**Office Action Summary**

10/798,814

## **DETAILED ACTION**

Claims 9, 10, 12, 13 and 15 are rejected under 35 U.S.C. 103(a) as being unpatentable over Yoshii et al. (US 6147724) in view of Lee (US 2002/0097353) further in view of Hasegawa et al. (US 5815224).

*FIG. 4A*

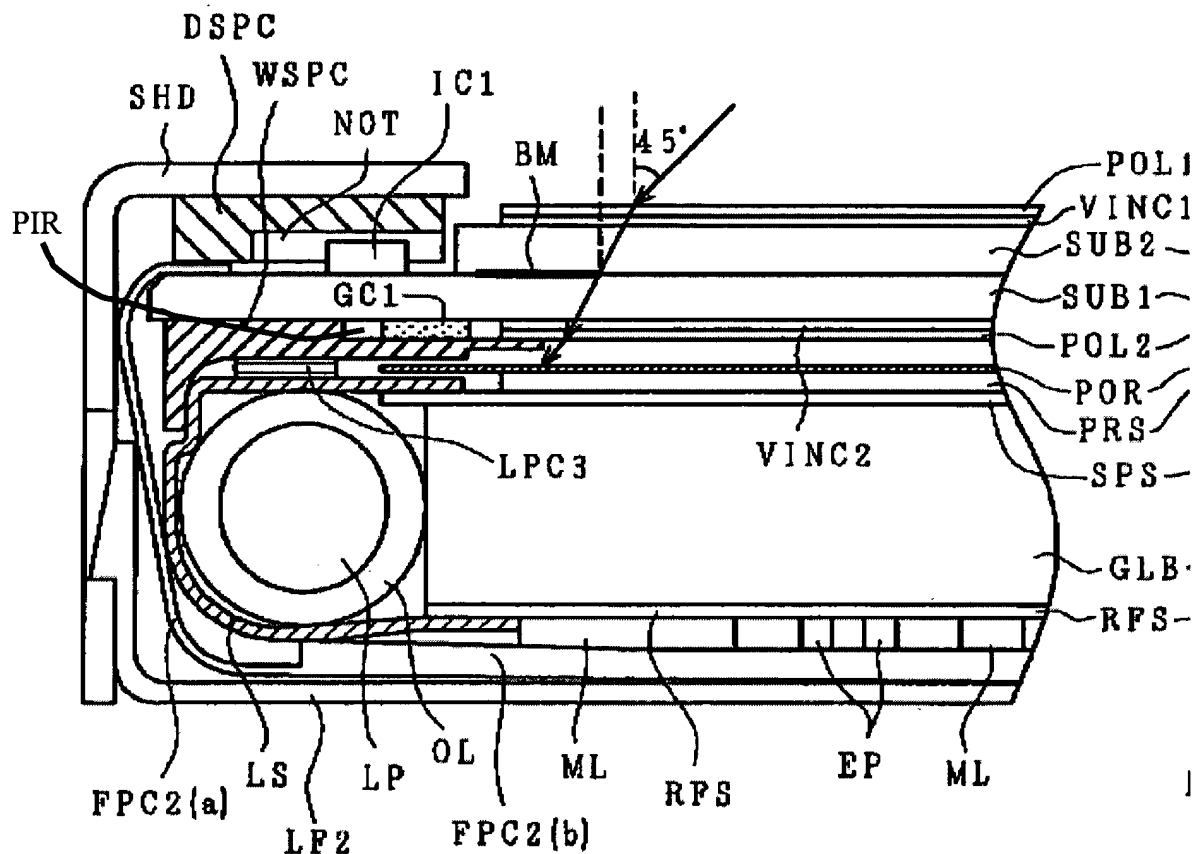
As to claim 12: Yoshii et al. further disclose in Figure 4A that the particle interceptor includes particle intercepting protrusions (element GC1) formed on the first face, and at least one particle intercepting recess (element PIR as shown in figure below) formed on the particle intercepting protrusions.
